**National Education Society for Tribal Students**  
(An Autonomous Organization under  
Ministry of Tribal Affairs, Govt. of India)  
Ground Floor, Gate No.3 A, Jeevan Tara Building,  
Parliament Street, New Delhi-110001  
Telephone No. 011-23340280  
वेबसाइट/Website: www.tribal.nic.in  
Email: nests-tribal@tribal.gov.in

**File No: NESTS/Civil/EMRS Order/140/2021-22(Pt.)**

**Sub: Consolidated guidelines on C/o EMRS Buildings – MLP, DPR, Architectural Drawings (Phase-1),  
Specification, Clarification & General Guidelines regarding.**

- vi. Updated drawings and details for School Building, Hostels, Kitchen & Dinning are enclosed at **Annexure 'B'**

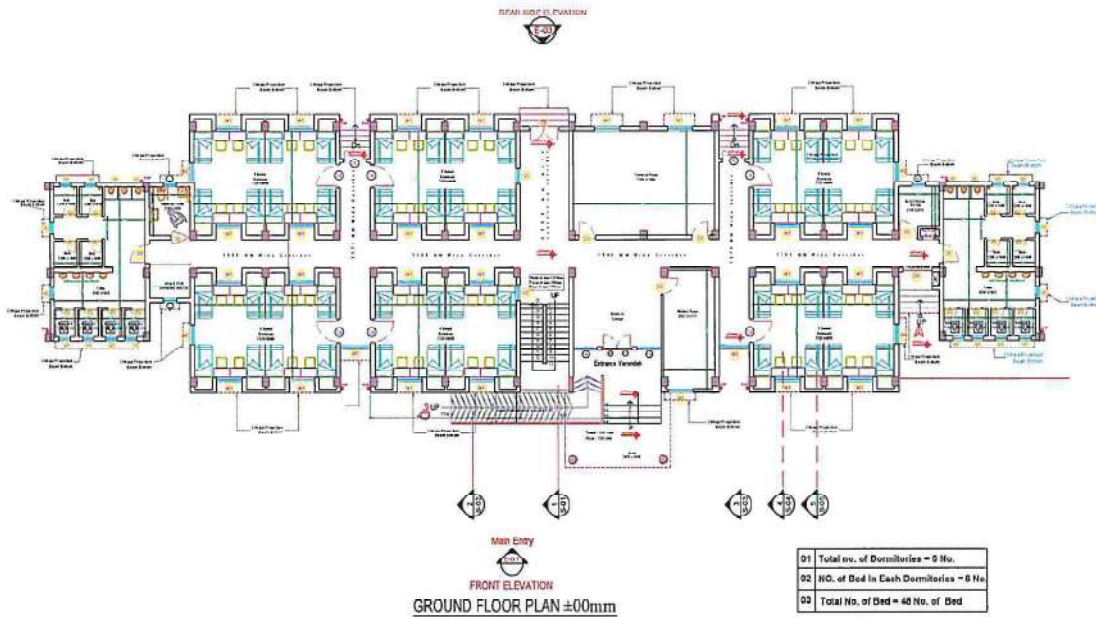
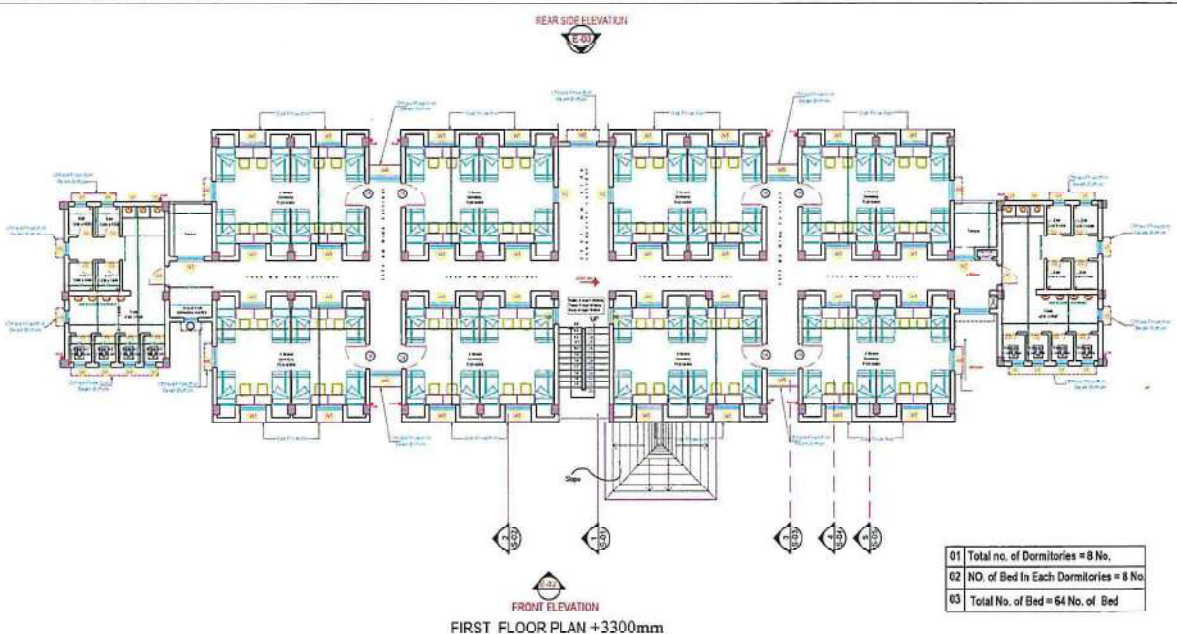
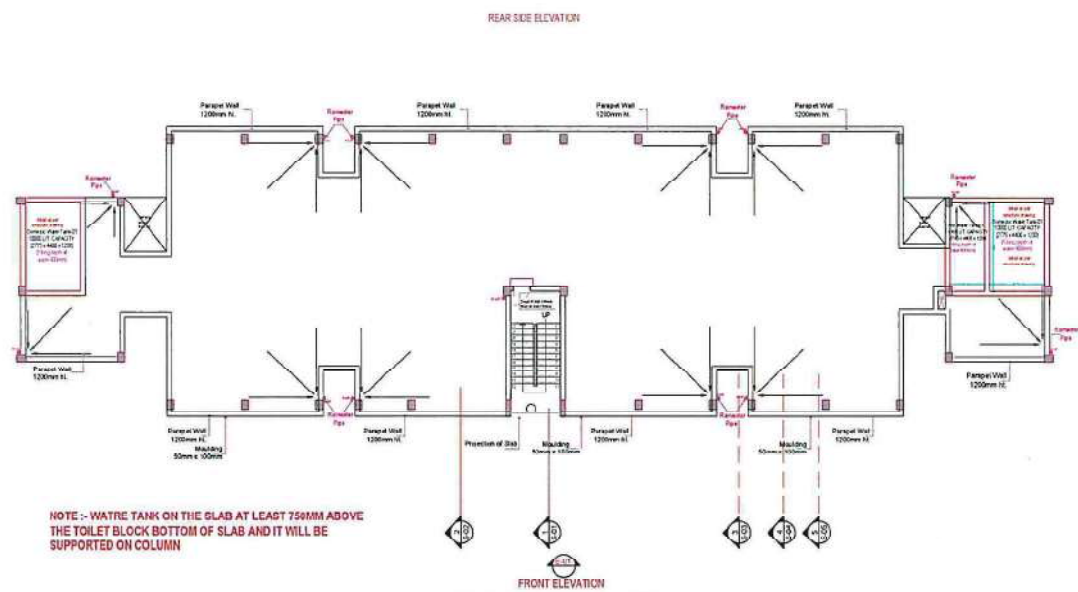
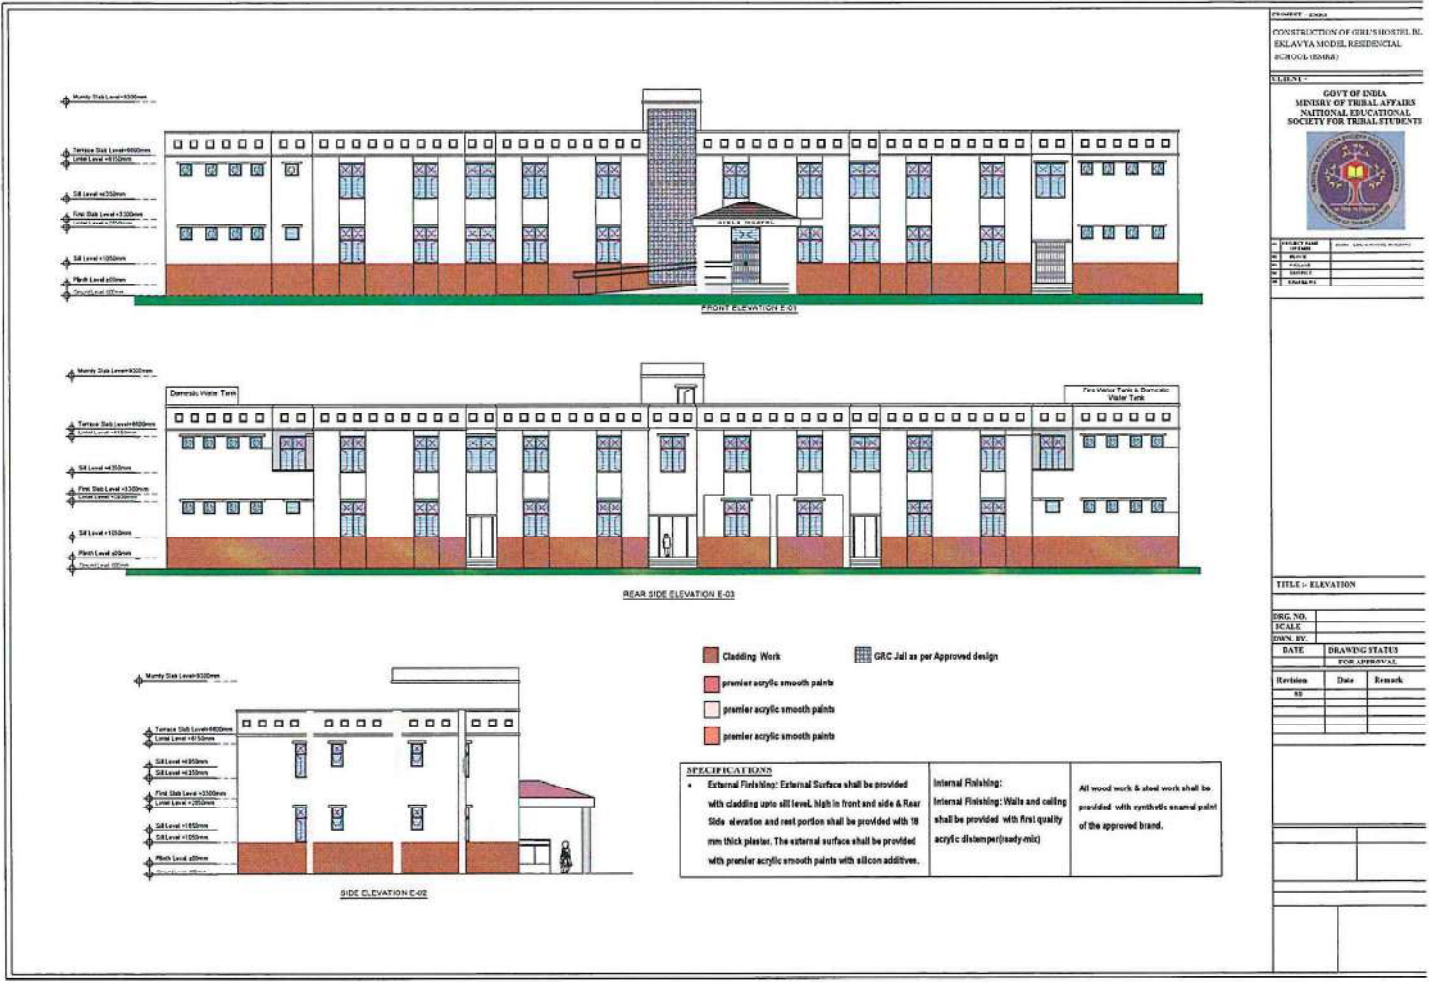
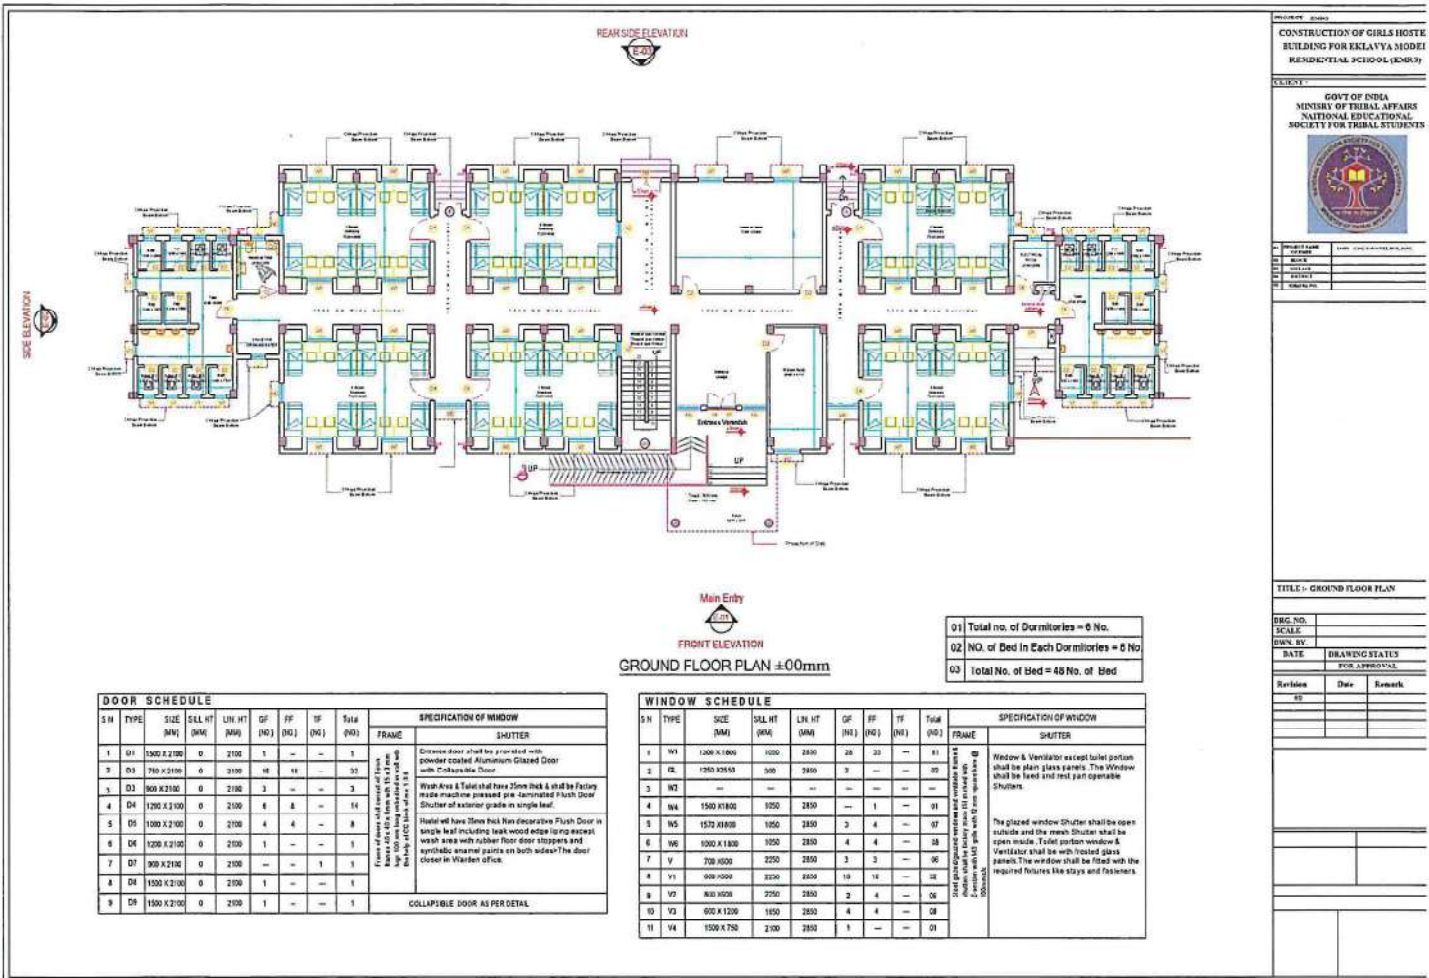
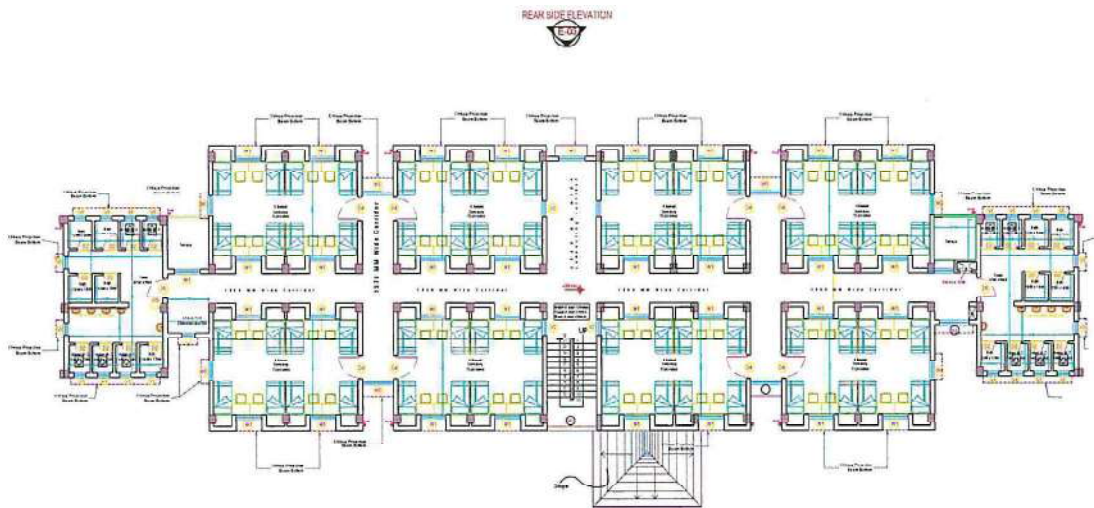
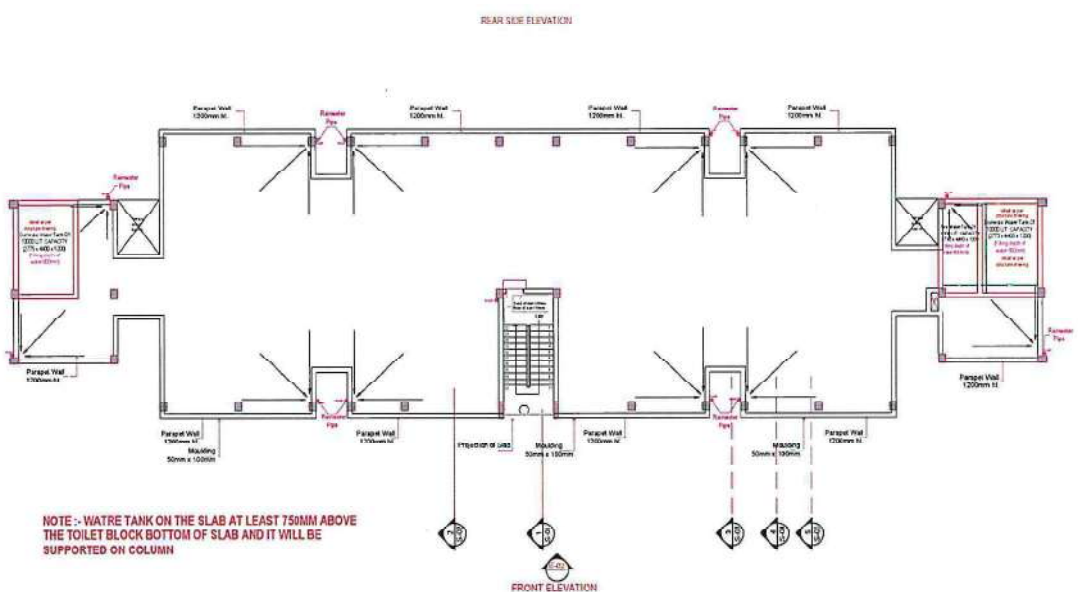
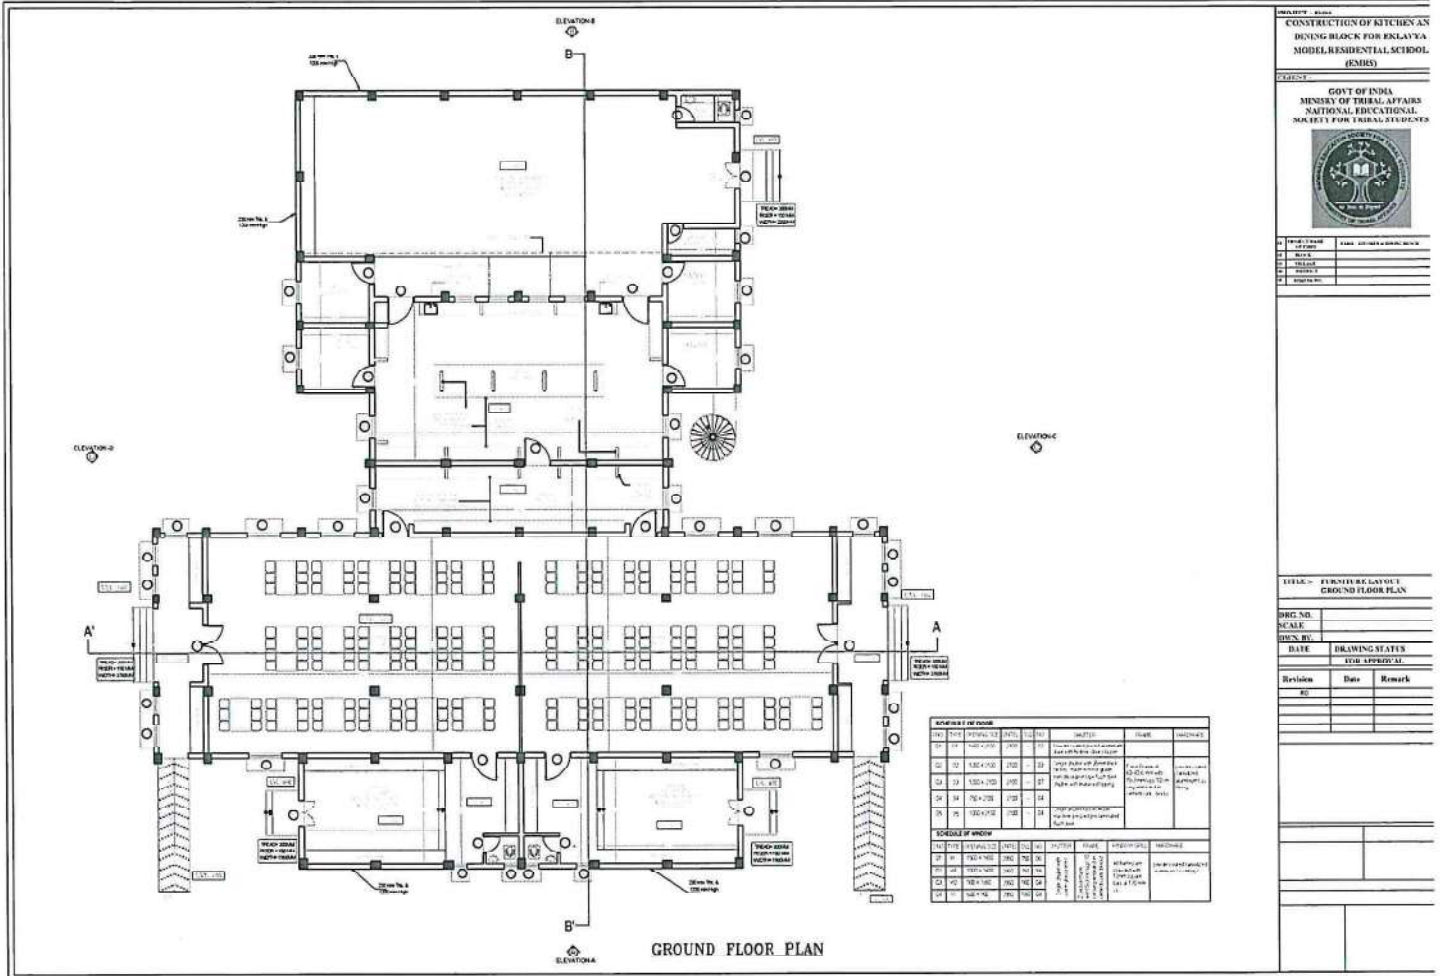
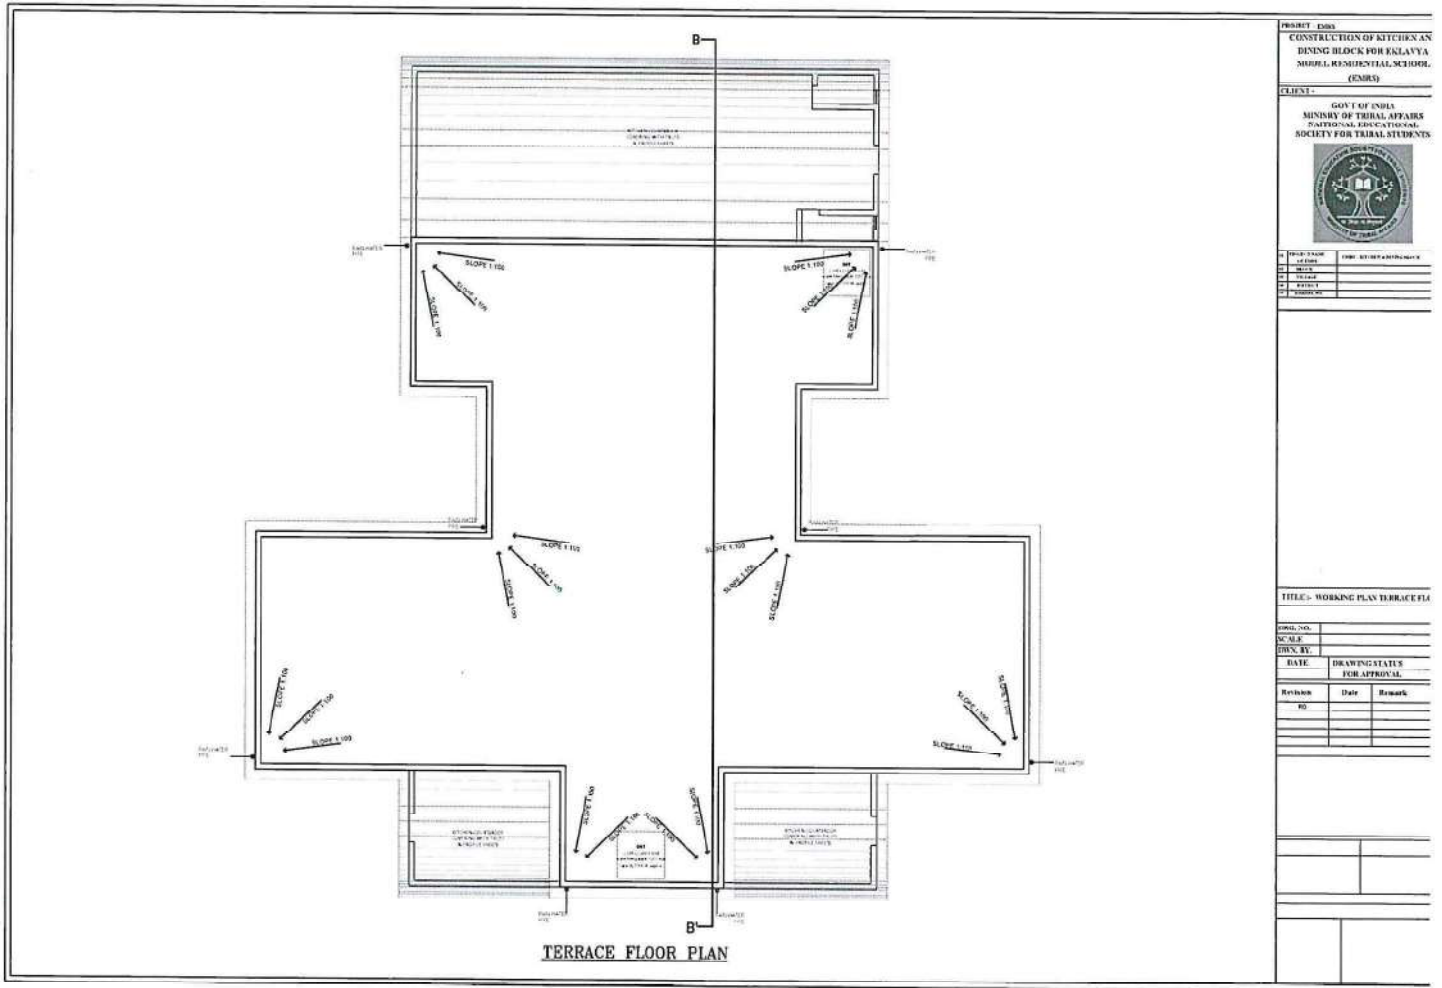
- i. The floor plans of all buildings were retained except toilet blocks of school & hostel buildings.
- ii. In CPWD based drawings, for toilet block, there was a common entry lobby for boys, girls and person with disability, which is not proper from service/safety point of view. Hence Toilet blocks were modified to provide separate entry and to accommodate drinking water facility. The orientation of washroom for differently abled person, boys and girls has also been modified in order to enhance utility with more ease.

- iii. The toilet blocks of hostels were cramped and hence area of bath and WC are enhanced to meet the NBC guidelines and for easy movement of students.

- iv. The rear stair cases of school building are taken upto First Floor only. The front 2 Nos of stair case will be taken upto mumty for restricting undesirable access to terrace.

- v. In school building, one bay at FF was kept void in approved drawing, which has been covered with roof slab to avoid dumping space in between the class rooms and for better aesthetic appearance.

**In respect of earlier approved DPR, where the work has just commenced or about to commence, the necessary modification as per architectural drawings shall be made, particularly toilet blocks of school & hostels.** Wherever, the foundation completed, the internal partition of toilets may be suitability modified to the possible extent.

**The construction agencies are requested to submit the working drawings of all buildings as per updated detailed drawings before commencement of works.**
